325 - 327 Deansgate – Manchester

S73 Minor Material Amendment | December 2023

10446-A-B5D8-RP-DAS-003

East (Century Street) Elevation - Proposed Amendments

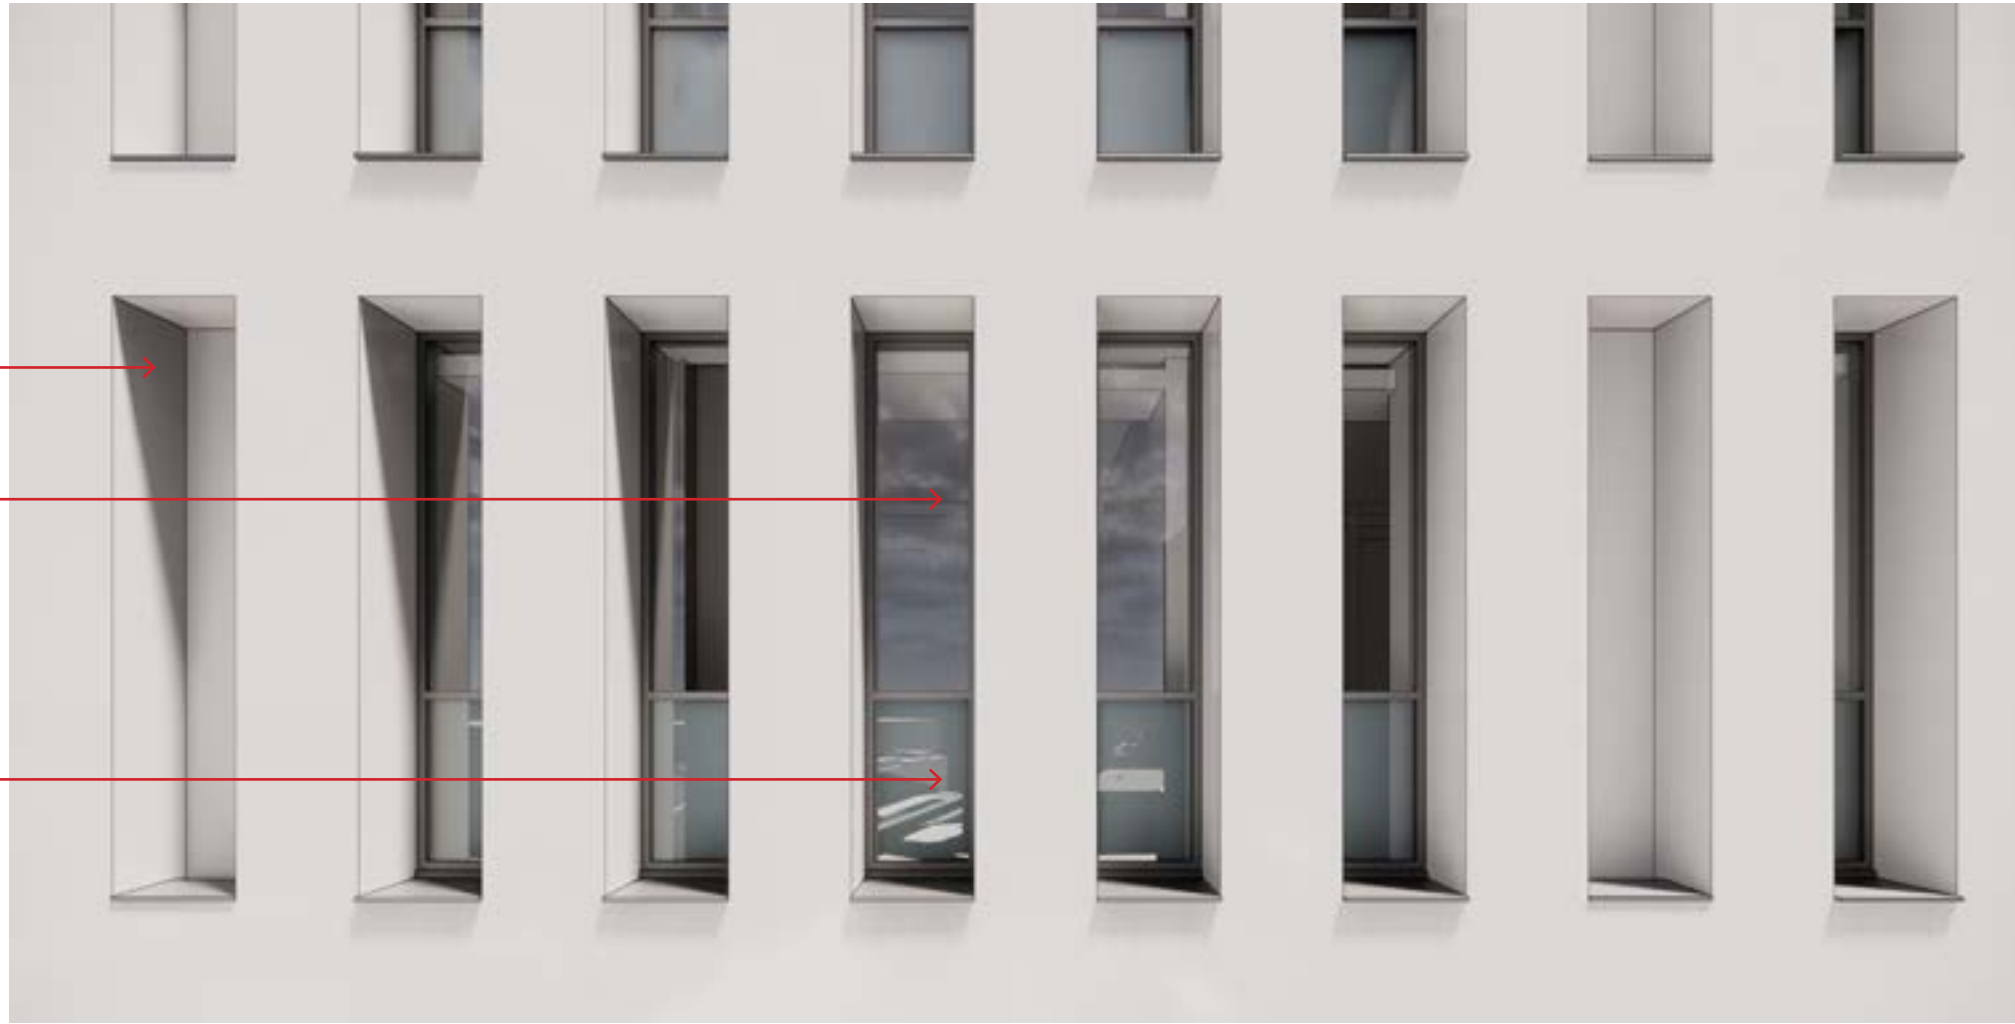
The consented and proposed East elevation include the same number of opaque windows to bedroom floors - with only the distribution changing

Solid reveals retained to end units - in keeping with consented scheme

The proposed amendments include the same 90 opaque window reveals, with the proposed distribution amended to suit the revised space planning and structural grid. The amended proposal retains the solid material reveals at each end of the floor plate, with opaque glass proposed in central locations.

Elevation Study - Proposed Amendments

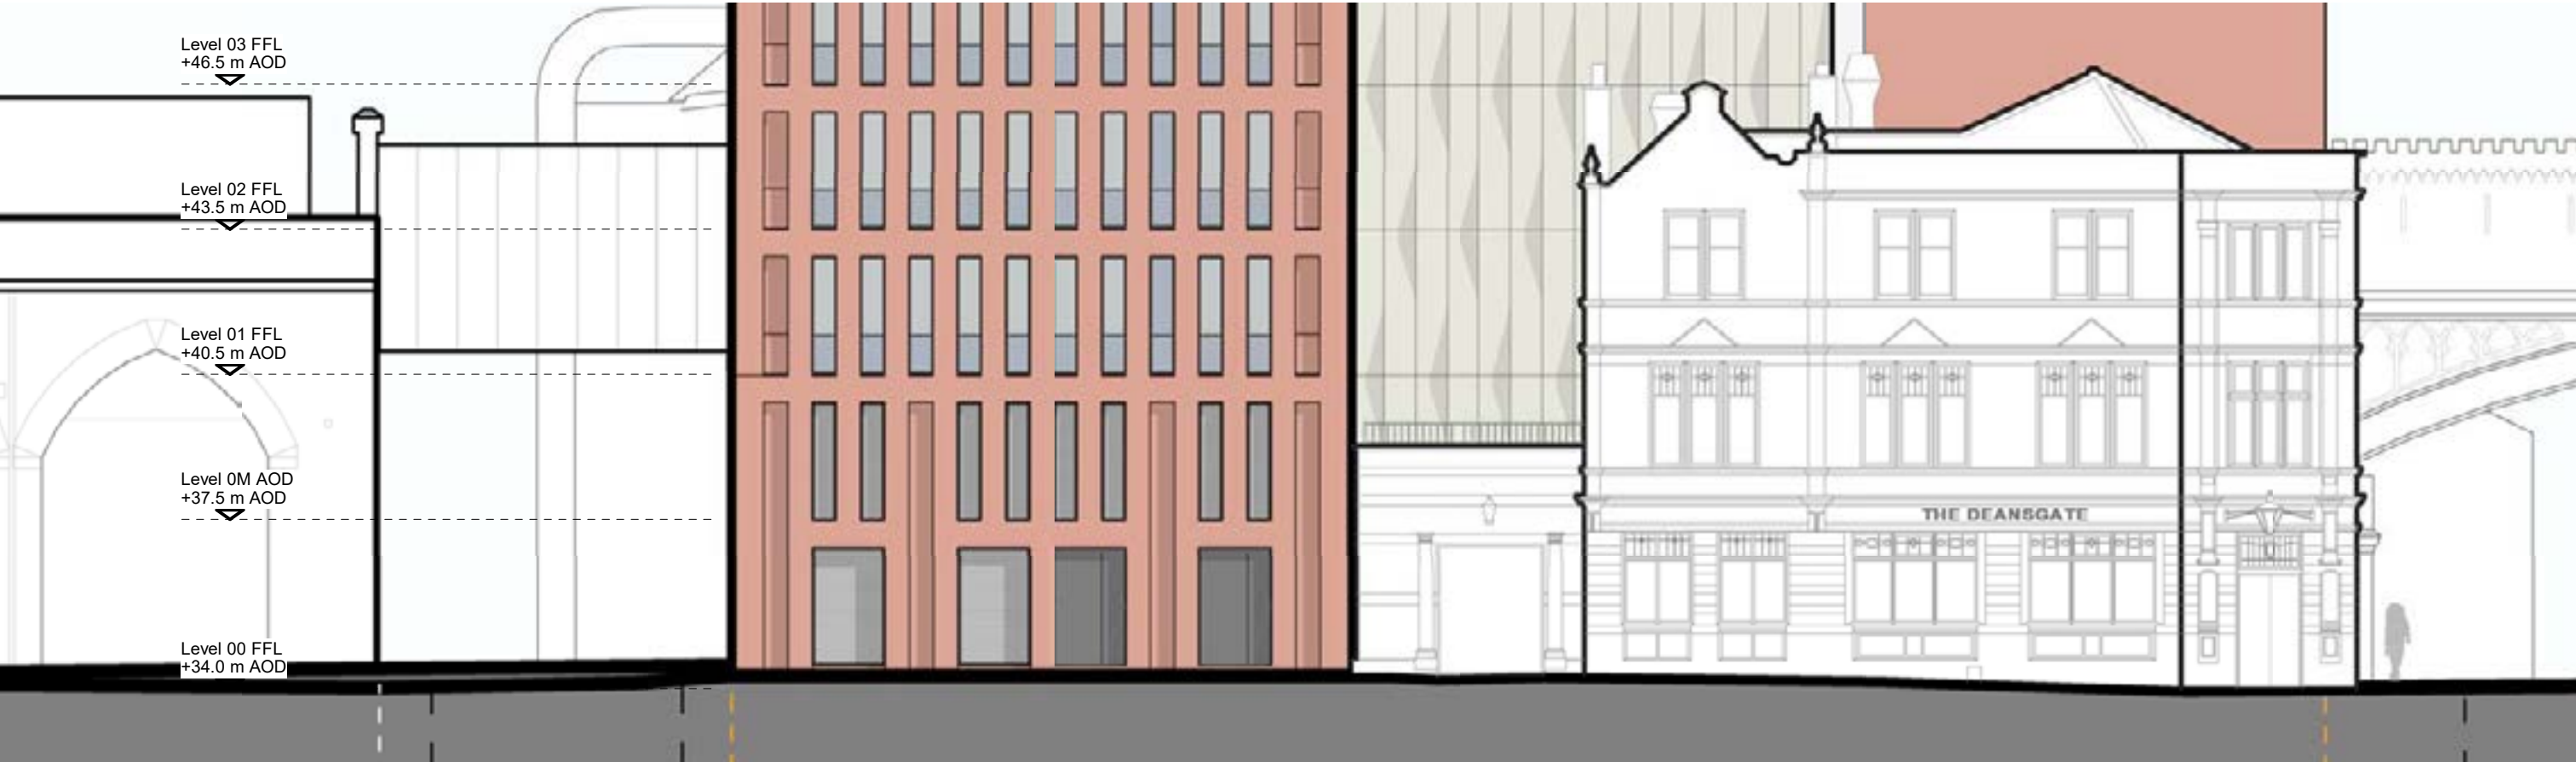
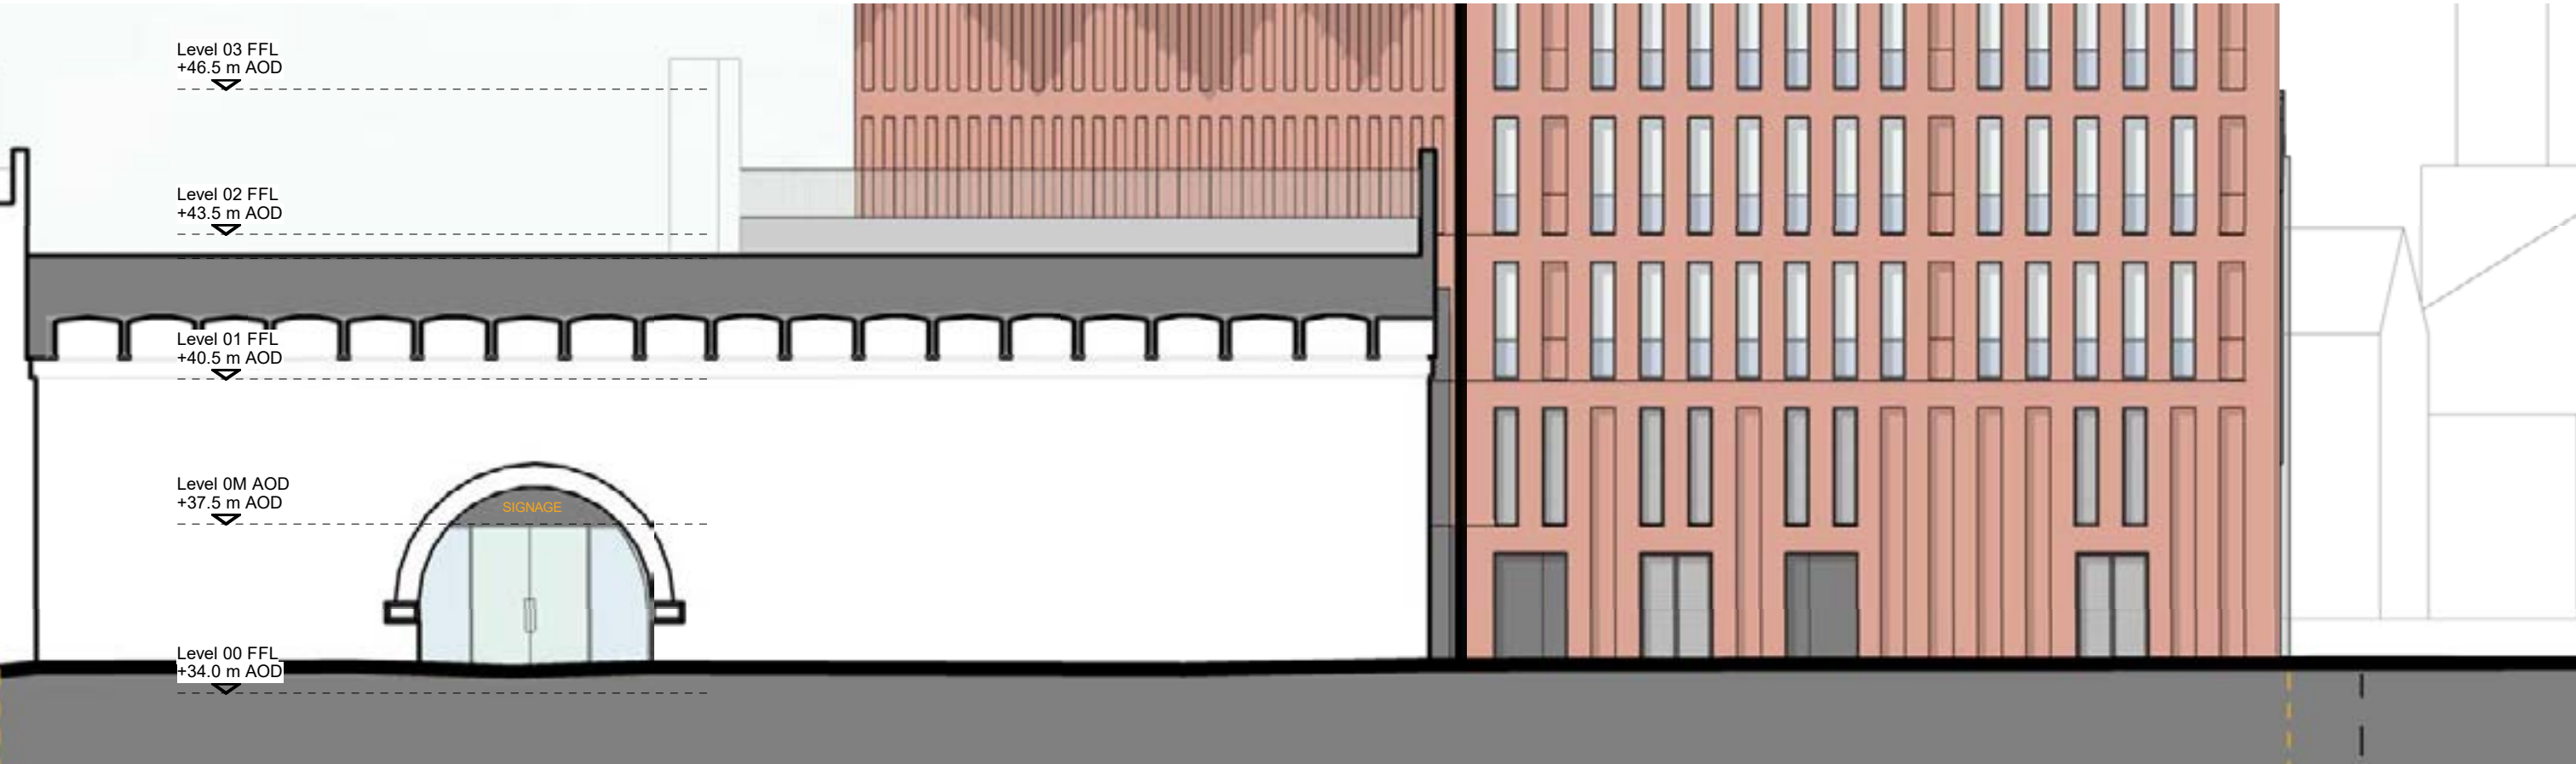
The adjacent images show a close up bay study of the consnted planning proposal facade, alongside the amended facade with redistributed opaque windows. The depth of reveal and repeated grid ensures that this is a very minor visual change to the proposals.
